UNITED STATES PATENT AND TRADEMARK OFFICE

Office Action Summary	Application No.	Applicant(s)	
	08/987,005	HOWELL, MATHEW G.	
	Examiner	Art Unit	
	A. Dexter Tugbang	3729

DETAILED ACTION

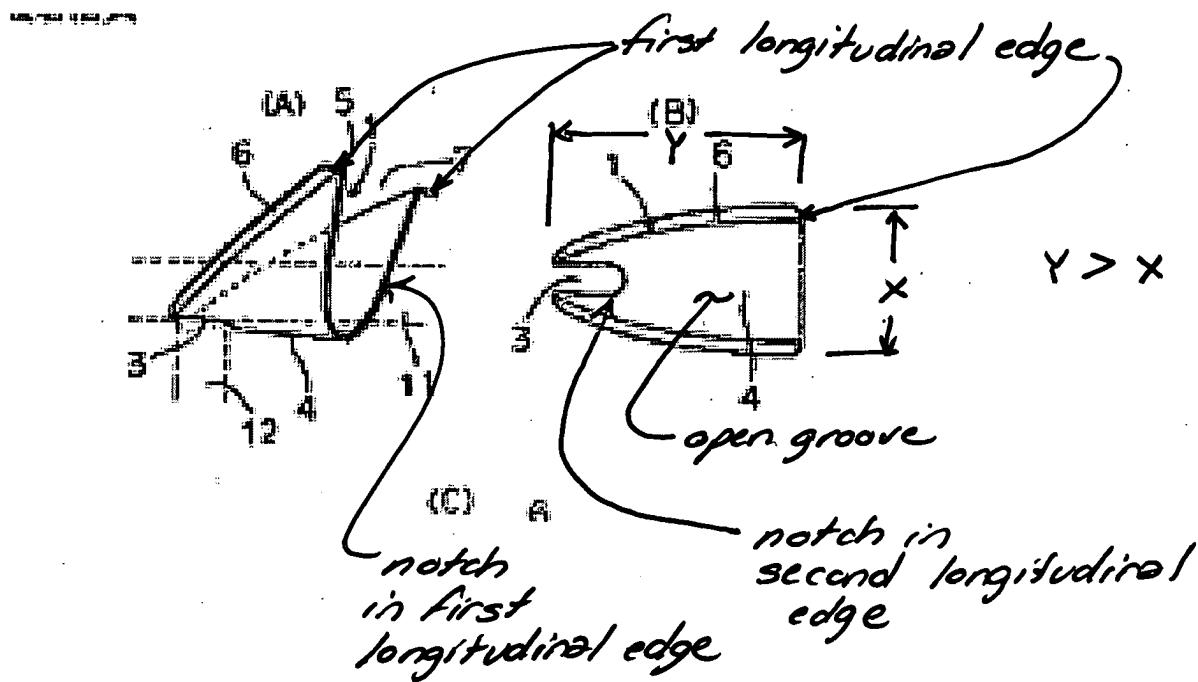
The applicant contends that JP'530 does not teach a tray with an "open groove defined by first and second longitudinal edges" (lines 2-3 of Claim 22 with similar limitations in Claim 29). The applicant asserts that no surface on the structure of JP'530 can be read as any "edge" and the examiner most respectfully disagrees with this assertion. For further clarification, the examiner illustrates below in Figures 1A and 1B of JP'530 as to what is being read as the claimed "first

edge" and "second edge" with the "first distance" labeled as the variable X and the "second distance" labeled as the variable Y.

So based on the illustration above, all of the limitations, particularly with reference to the claimed "first and second longitudinal edges", are fully met by JP'530.
